BUFFALO RIVER WATERSHED ALLIANCE

Comments on Regulation 6 Revisions

Submitted via electronic delivery to reg-comment@adeq.state.ar.us
September 23, 2019

The following are comments from the Buffalo River Watershed Alliance on proposed revisions to APC&EC Regulation 6 (Regulations for State Administration of the National Pollutant Discharge Elimination System (NPDES)), Markup Draft July, 2019.

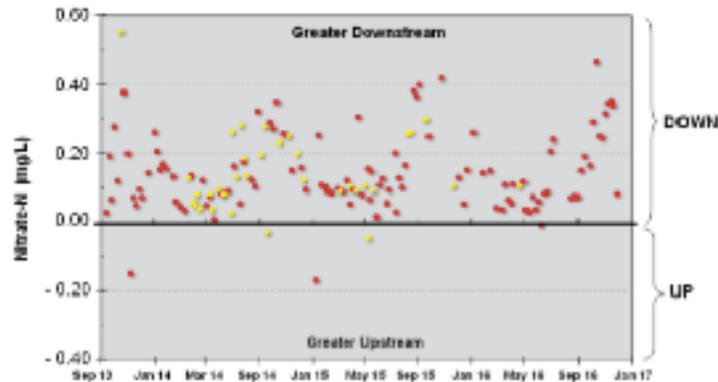
Nitrates are being measured by the *Big Creek Research and Extension Team* (BCRET) of the *University of Arkansas Division of Agriculture* both upstream and downstream of the facility and nearby spreading fields Figure 1.

Regarding this data illustration, Burkholder in a report to Buffalo River Watershed Alliance (2017) states:

“The data clearly indicate that the C&H CAFO is contributing swine waste pollution to adjacent public trust waters. The nitrate levels downstream from this CAFO commonly are levels that have been shown in other research to be toxic to sensitive aquatic life (Camargo et al. 2005, Guillette et al. 2005). The nitrate signal is stronger than the E. coli signal because nitrate does not adsorb to sediment particles and settle out (Stumm and Morgan 1996); instead, nitrate is highly soluble and is transported rapidly from swine CAFOs to receiving surface and groundwaters (Evans et al. 1984, Stone et al. 1998, Ham and DeSutter 2000, Mallin 2000, Krapac et al. 2002), the latter problem being exacerbated in underlying karst geology (Mellander et al. 2012, Knierim et al. 2015) which is characteristic of the region that includes the C&H CAFO (Hudson et al. 2001, 2011).”
